BG Collection Ltd. (10959)

Client Summary Report

Observations & Actions

ACCORD
on Fire and Building Safety in Bangladesh

Permission Layout

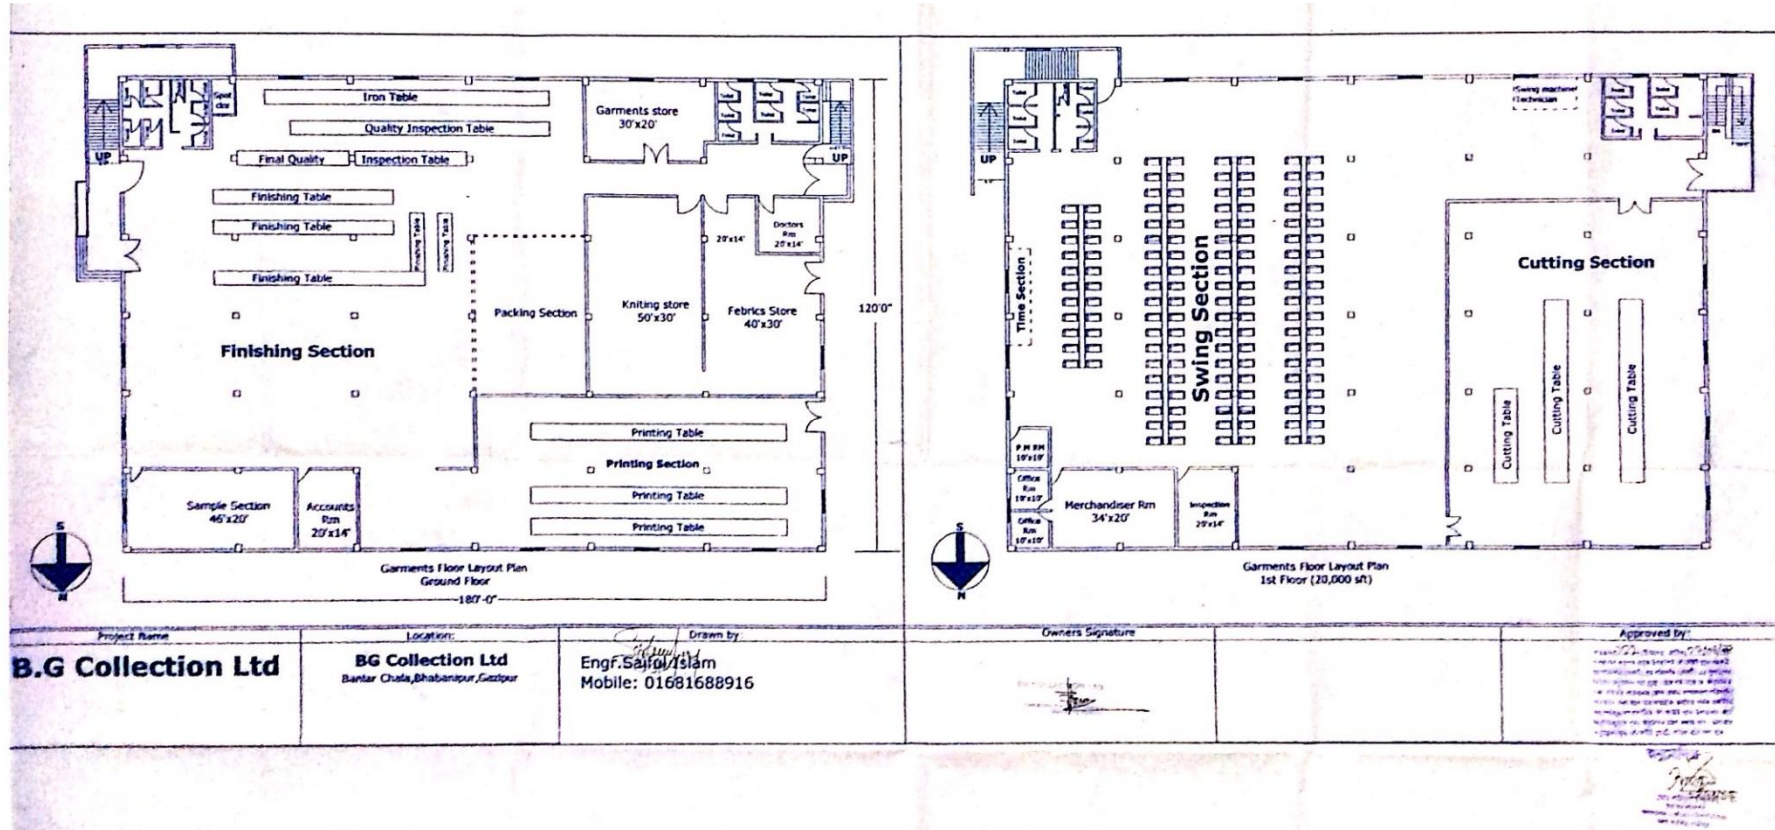
This building was proposed to be a 2-storey building and was approved by a local authority in 2014. We were informed that this building actually dated from 2005 and was completed in 2007.

1st Priority 2 Concern

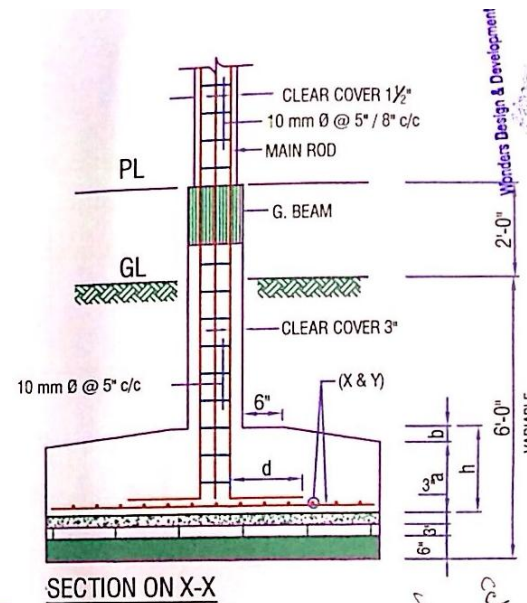
Inadequate steel detailing on the, rafter connections to concrete columns, steel roofs over staircases & the dining shed.

- Carry out Engineering Assessment on steel roof to determine if any strengthening works are required.

- Carry out recommendations highlighted in Engineering Assessment.

1st Priority 3 Concern

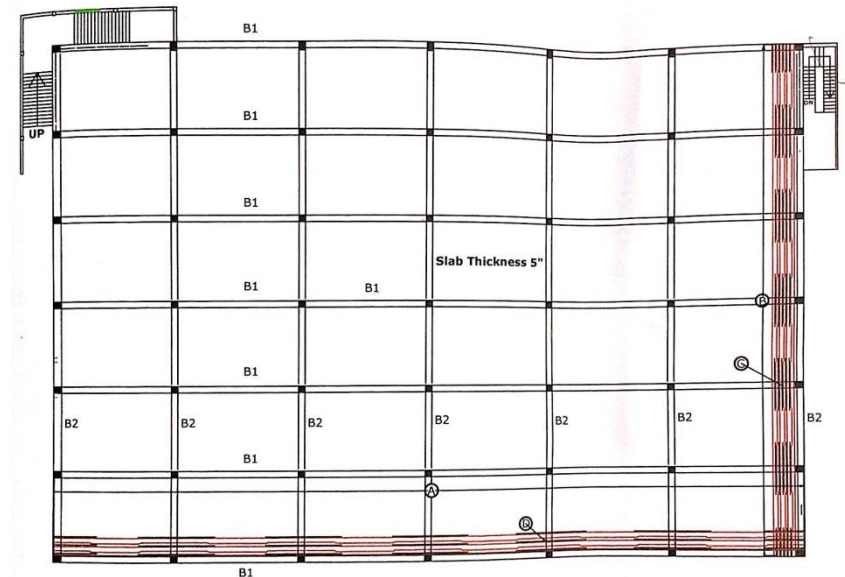
Structural “as built” drawings show information based on back calculations, the plan drawings are not dimensioned and some drawings are incorrectly titled.

- Building Engineer to survey the as built condition and update the structural drawings, paying close attention to the column and beam size.
